**Bidding Requirements, Contract Forms and Conditions of the Contract**  
**ADDENDUM**  
Section 00900

**ADDENDUM No.**   1

Project Name  Southeast Allandale Neighborhood Water and Wastewater Improvements Rebid (IFB 6100 CLMC 538B)

C.I.P. No.  2231.192

SHEET NUMBER 23 OF 133

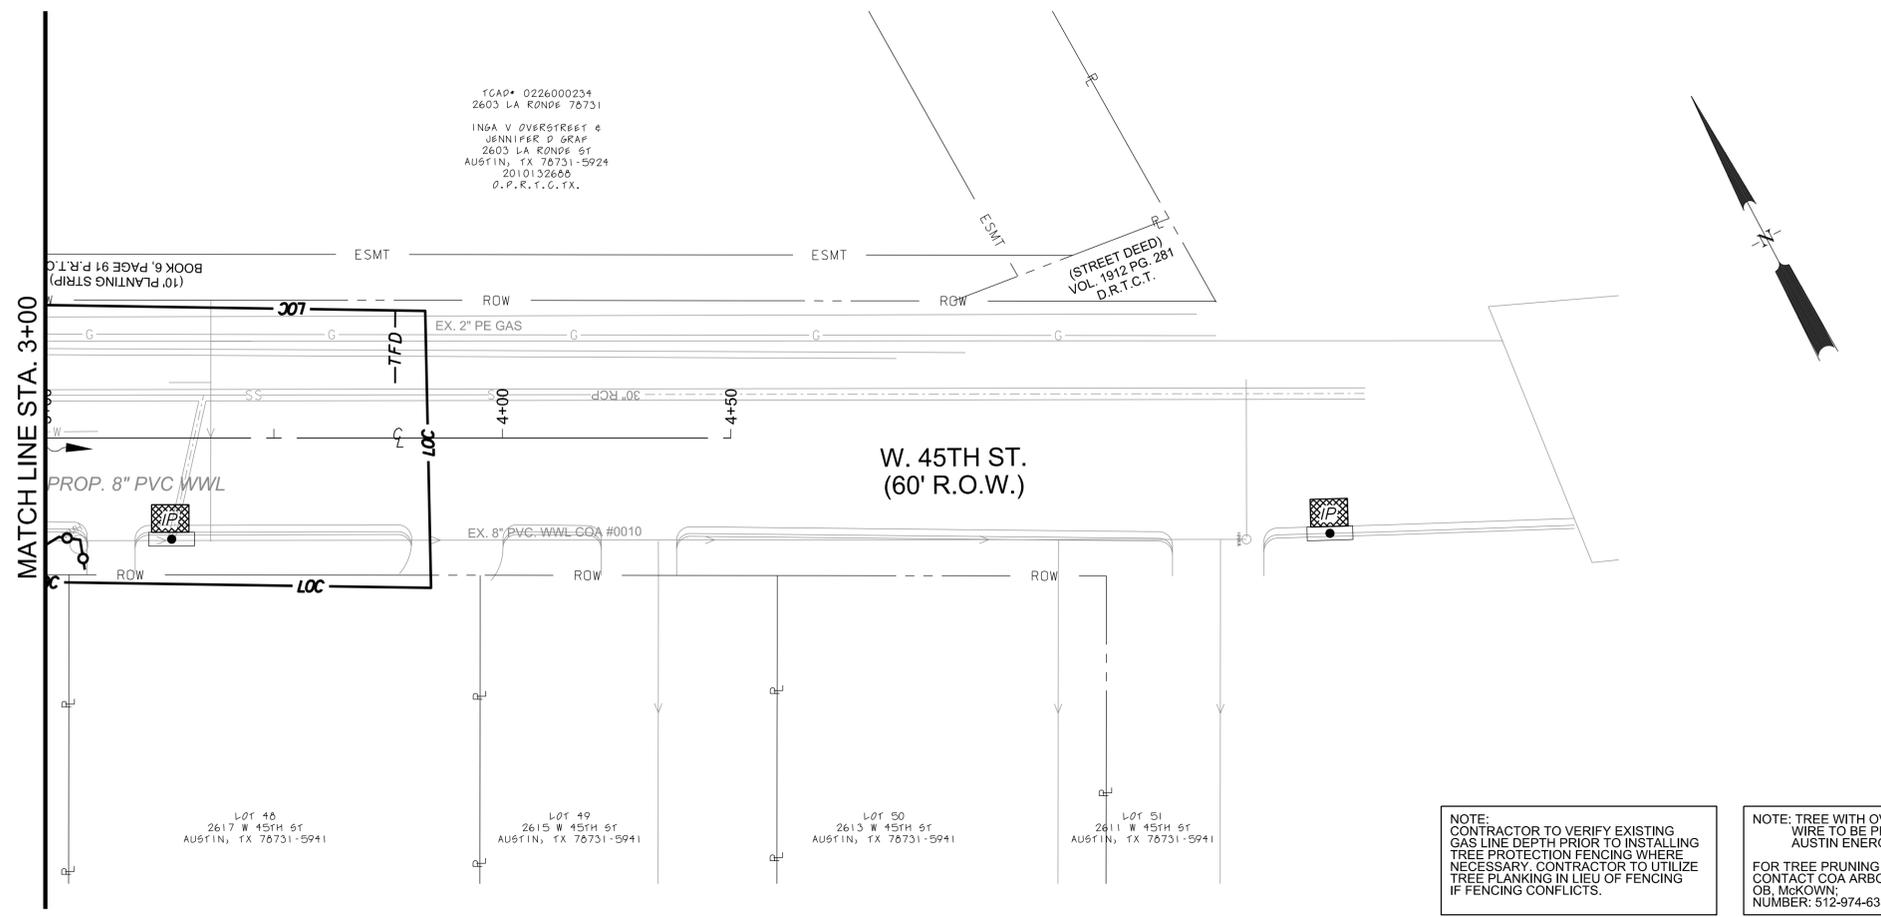
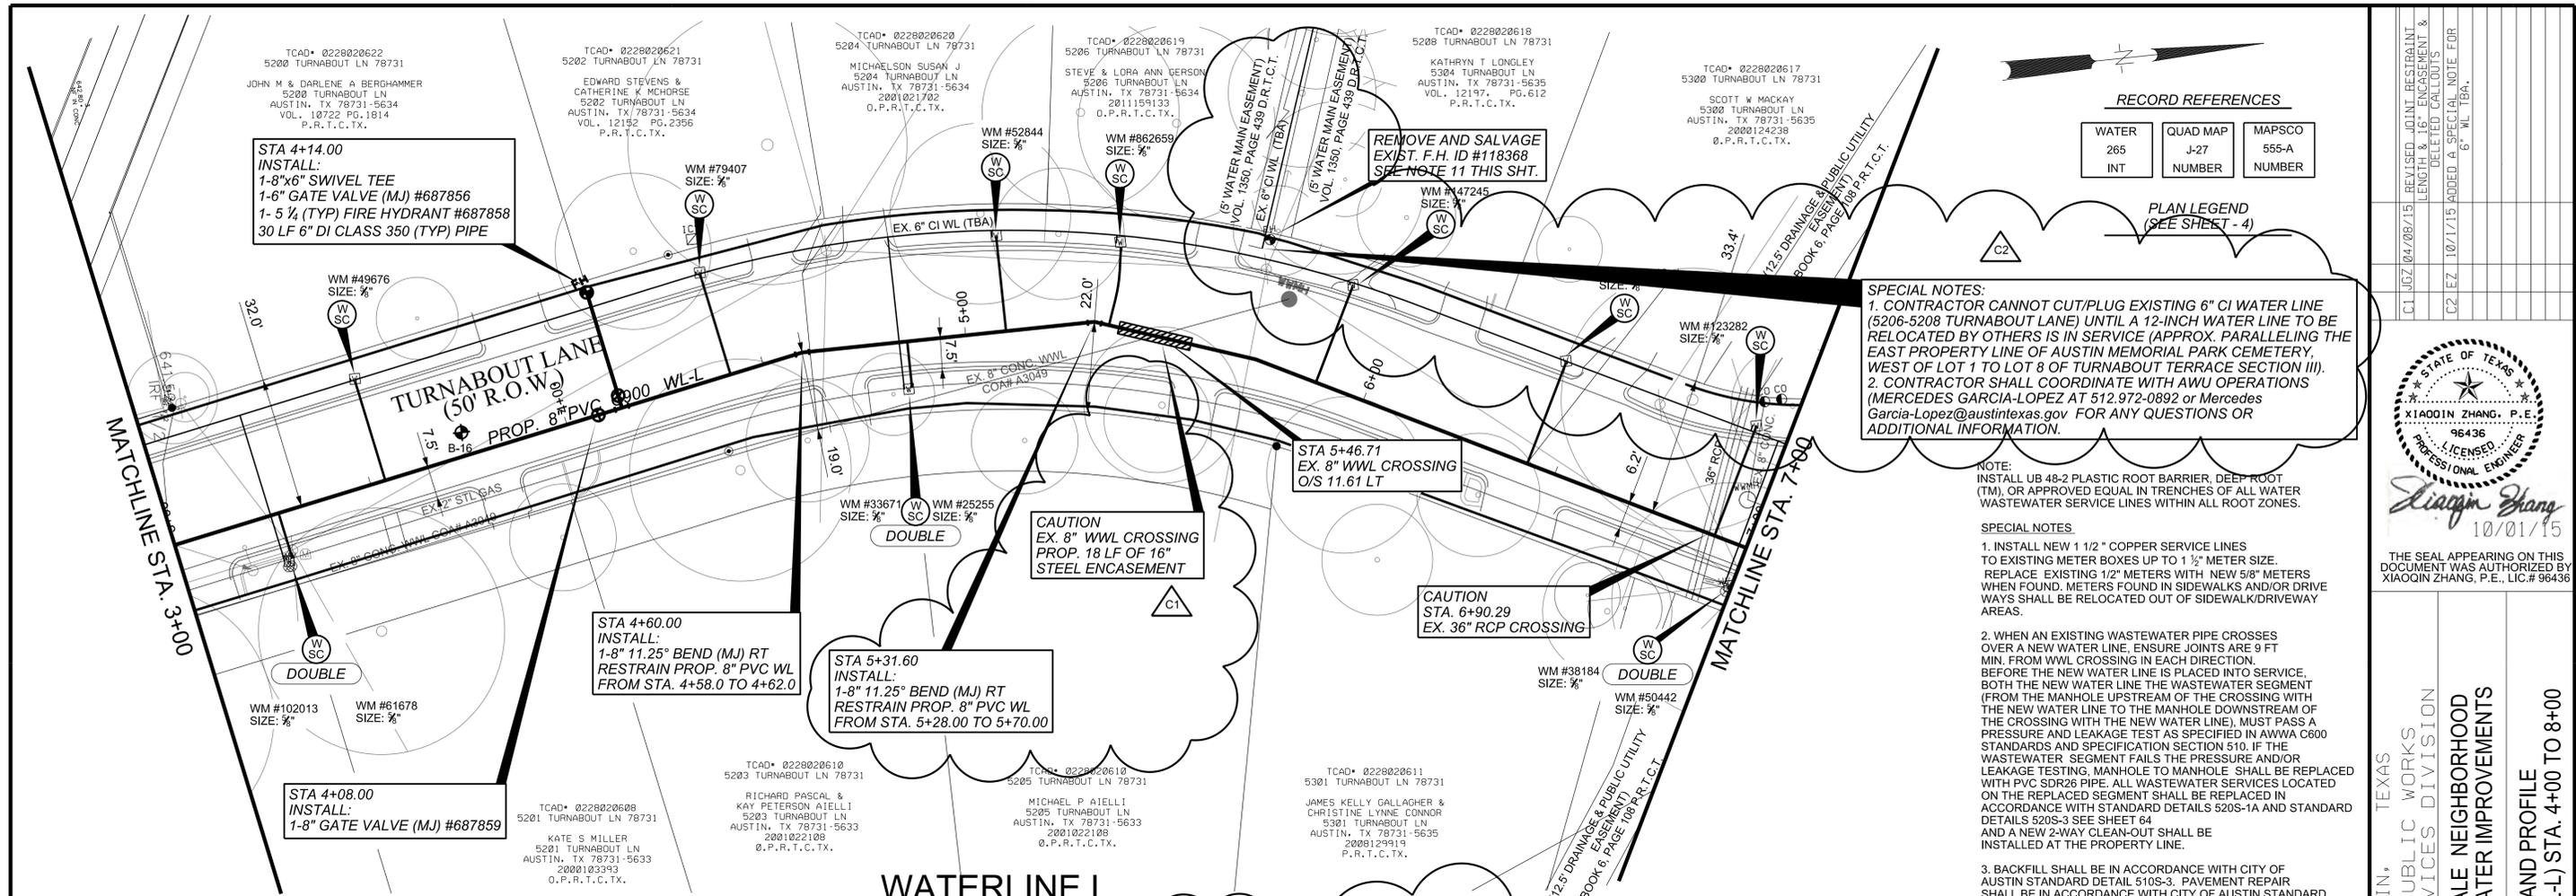
REV. NO.	DATE	REVISION DESCRIPTION
1	04/08/15	ADDED TREE PROTECTION
